Ref: 93-F-0479

C-17 FLIGHT TEST PROGRAM

DECISION BRIEF TO PEO
ON
USING STATIC WING ARTICLE
FOR
LIVE FIRE TEST

C-17 LIVE FIRE TEST AND EVALUATION DETAILED TEST PLAN HYDRODYNAMIC RAM TEST

Figure 3.2 Pressure Probes Through Front Spar.

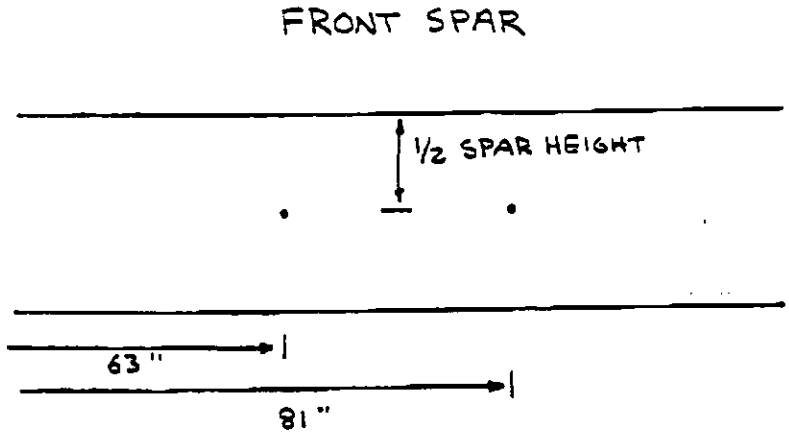
- The Air Force should verify that the front spar material on the test article is identical to that on the actual wing. (Until we received your July 1 memorandum stating that this material would be changed from 6061-T6 to 7075-T6511, it was our understanding that the test article spar material was the same as that on the actual wing.)

- NO MODIFICATIONS
  - STIFFENER MATERIAL CHANGE MADE MAY 92

AIR FORCE-PROPOSED C-17A WING LEADING EDGE TEST ARTICLE

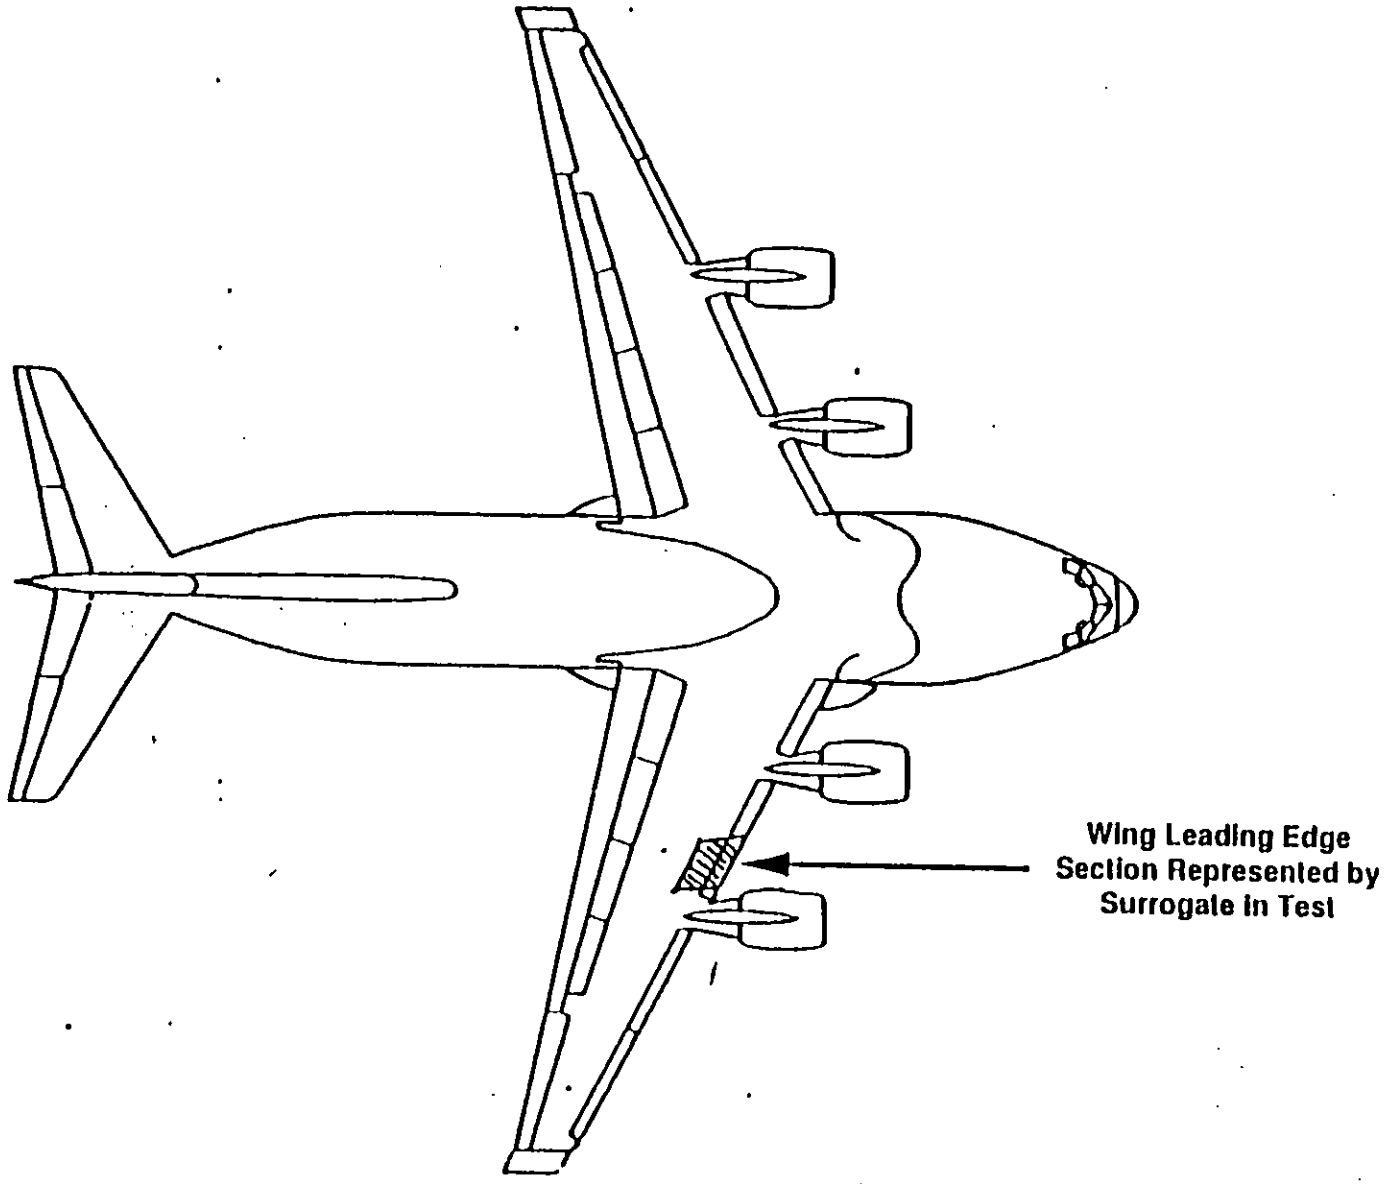
There is a question whether the impacting 12.7 mm API round will function the same on the proposed test article slat as it would on the actual C-17A wing slat. The problem is that the titanium surface of the slat on the production aircraft is chemically milled to a thickness of 0.063", while the titanium surface on the slat of the test article is a constant 0.071". The document mentions that a reference report shows no difference in functioning for 0.063" to 0.071" thickness in the range of expected impact angles. Unfortunately, the title of the referenced report is not included.

If an API round passes through the slat, dry bay, front spar, and into the fuel tank, there is a good chance that no fire will result since the incendiary may burn out before it can come into contact with fuel leaking from the tank. In such a case, the test article may provide results different from the actual aircraft wing.

e. Difference in API functioning due to differences in Titanium skin thickness on slat. The four shotlines planned will impact in areas where the production skin will have been chemically milled to .071 or slightly thinner. The reference report used shows no difference in functioning for .063 to .071 thickness in the range of expected impact angles; therefore, this should be of no concern.
